# **Staff Report**

# Infill Housing Design Review Committee

File Number: 11-B-20-IH

Location: 1215 Texas Ave. Parcel ID 81 | V 016

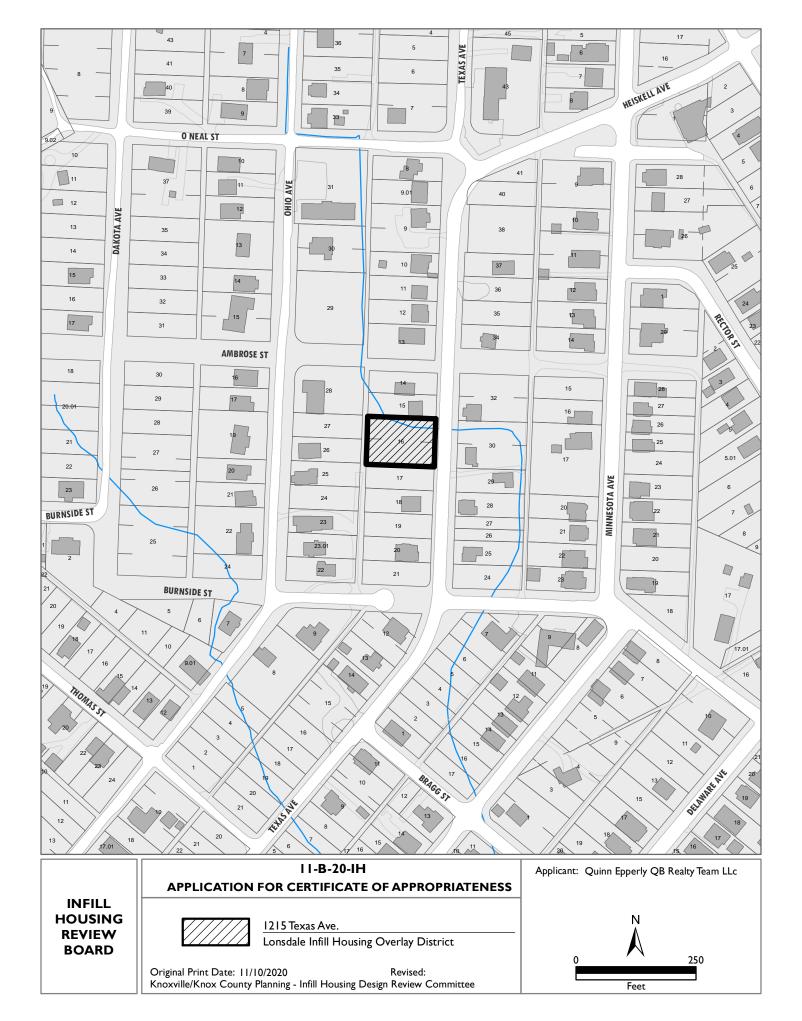
- 1. The house is proposed with a front setback of 20.5' from the front porch to the property line, and 28.5' to the primary residence. The proposed new construction at adjacent 1219 Texas Avenue will reflect the same setback pattern. The proposed front setback will maintain front yard spaces consistent with the rest of the block. A walkway should be provided from the front door to the street.

- 2. The 1200 block of Texas Avenue features a variety of simple housing styles, including several Queen Anne cottages, Minimal Traditionals, and some contemporary infill construction. A one-story, modestly-sized house is somewhat smaller in scale than other houses on the block. A 24' wide façade is smaller than original houses on the block; guidelines recommend that front facades of new houses be comparable in width to original houses on the block. Foundation height should be verified to reflect heights of original houses in the surrounding blocks.

- 3. The 8' deep front porch meets the design guidelines for size and placement. Guidelines recommend porch posts to reflect those used in the historic era of the neighborhood's development; porch supports should be more substantial in size or use additional detailing to meet design guidelines.

- 4. Guidelines recommend window and door styles to be comparable to original or historic houses on the block; the square-shaped, 8/8 vinyl windows on the façade are not compatible with historic styles. Additional windows are necessary on left and rear elevations to provide transparency and add to the "ratio of solids to voids."

- 5. The proposed roof has an 8/12 pitch, which is sufficiently steep to meet the design guidelines. Horizontal siding also meets the design guidelines; applicant should select a lap siding instead of Dutch lap or horizontal planks to reflect historic context.

- 6. The applicant proposes to extend the driveway off Texas Avenue. While guidelines encourage using operable alleys whenever possible, the alley on the 1200 block of Texas Avenue stops behind 1227 Texas Ave. City Engineering has confirmed the alley is not operable behind 1227 Texas Ave, so access will have to extend off Texas Avenue. If there is no operable alley in place, guidelines recommend that proposed parking pad is at least 20' behind the façade of the proposed house and screened by landscaping or fencing.

- 7. The site plan shows native shade trees in the façade and rear yards, which meets design guidelines for landscaping. Landscaping is shown to surround the parking pad in the rear.

- 8. A 10' by 10' rear porch is shown on the site plan but not elevation drawings.

Staff recommends approval of the work as proposed, with the following conditions:

- 1) Use horizontal lap siding instead of Dutch lap or horizontal panels to reflect historic siding patterns;
- 2) Use larger square porch columns or select further detailing to meet guidelines for porch details;
- 3) Use a foundation height and cladding materials comparable to foundations of original houses on block;
- 4) Instead of square windows proposed for façade, use rectangular, double-hung windows on façade to better complement historic houses in block and side elevation windows;
- 5) Additional windows added to left and rear elevations, with approval by staff;
- 6) Parking to meet City Engineering standards.

Page 4 of 4	Planner in Charge: Lindsay Crockett	11-B-20-IH	11/12/2020 9:50:25 AM
7) Provide a walkway	y from the front door to the street
